SIB 11 07 23

VOLUNTARY EMISSION RECALL 23E-A05: REPLACE SWITCHABLE ROCKER ARM

2026-08-05

This Service Information Bulletin (Revision 9) replaces SI B11 07 23 **dated February 2025.**☐ THIS REPAIR IS MOBILE FRIENDLY

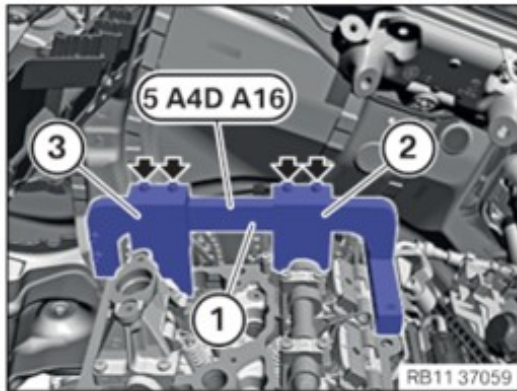
1. **The Repair Instruction 11 33 055 currently states to remove both intake and exhaust VANOS central bolts. It is not necessary to remove and replace the “intake VANOS central bolt,” only remove and replace the “exhaust VANOS central bolt.”**
1. **The current repair instructions may state to replace the “VANOS gears.” Please do not replace the VANOS gears.**

The repair instructions state to install specific tools to set the camshaft timing after reinstalling the exhaust camshaft.

You must install all of the tools shown in this step to ensure the timing is correct on both the intake and exhaust camshafts. Always tighten the screws to the proper torque.

Improper camshaft timing can result in various VANOS faults and or Mixture Adaptation faults.

- Position the setting gauge 0.5° (3) from the set of special tools 5 A4D A16 between the exhaust camshaft and the basic carrier (1) from the set of special tools 5 A4D A16.
- Position the setting gauge 0.7° (2) from the set of special tools 5 A4D A16 between the intake camshaft and the basic carrier (1) from the set of special tools 5 A4D A16.
- Tighten screws (arrows).

Tightening torques

Test gauge to basic carrier

M6

Tightening torque

8Nm

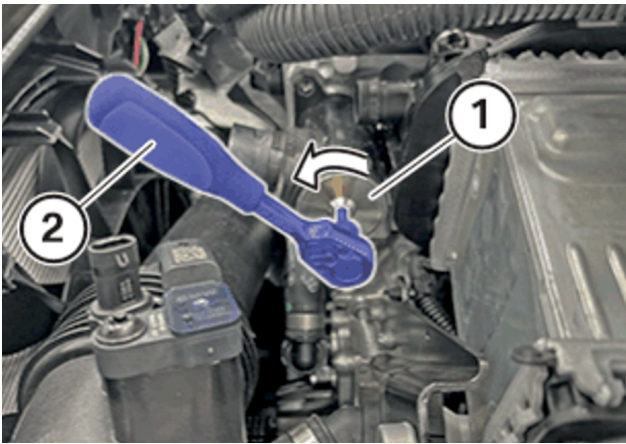
The crankshaft must be pinned/locked with special tool 2 288 380.

Both camshaft adjusters (VANOS gears) must be locked with special tool 5 A53 587.

The timing chain must be pretensioned using special tool 2 455 654 to ensure the timing chain is installed correctly. Refer to Repair Instruction 11 31 005 "Adjusting the timing of the camshafts", see step 8. This center button the special tool will identify if the chain is correctly tensioned, over- slackened or over-tensioned.

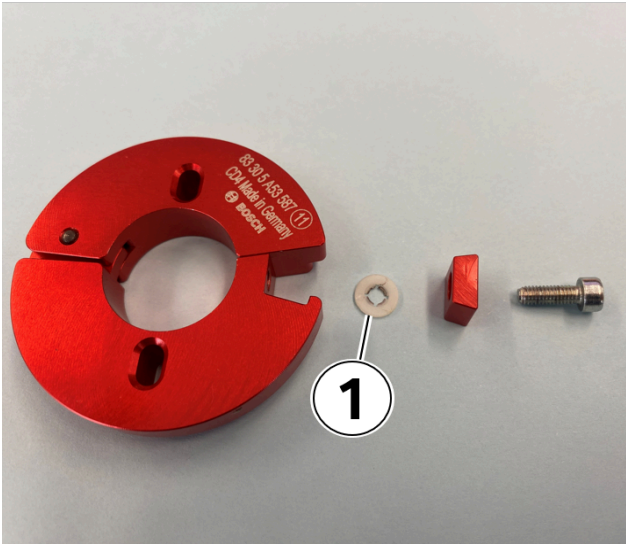
Cylinder 6 intermediate lever may interfere when trying to install the intake camshaft timing tools.

Place the variable valve timing (VVT) motor in minimum lift before installing the camshaft timing tools.

Use a 4 mm Allen socket (1) and a ratchet (2) to turn the VVT motor counter clockwise until it stops at the minimum lift end stop.

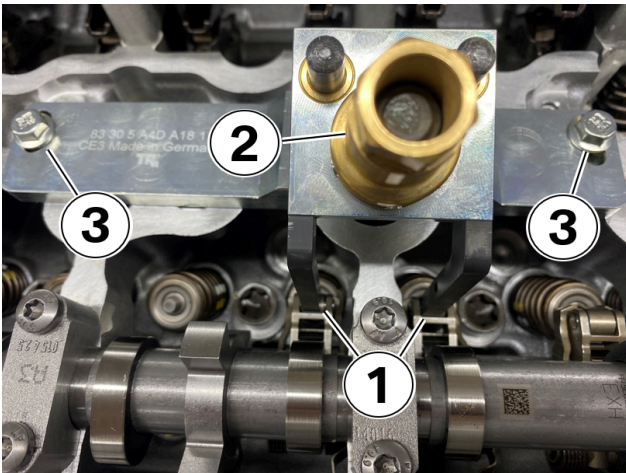
Tool 83 30 5 A53 587 may bind when removing it from both of the VANOS adjusters, the plastic washer (1) may be binding the tool and will not allow it to collapse when the screw is loosened.

Using a fine metal file, reduce the outside diameter of the plastic washer by approximately 1 mm to avoid this interference.

Removing the washer entirely could result in the screw and wedge falling into the engine, the washer avoids loosening the screw too much.
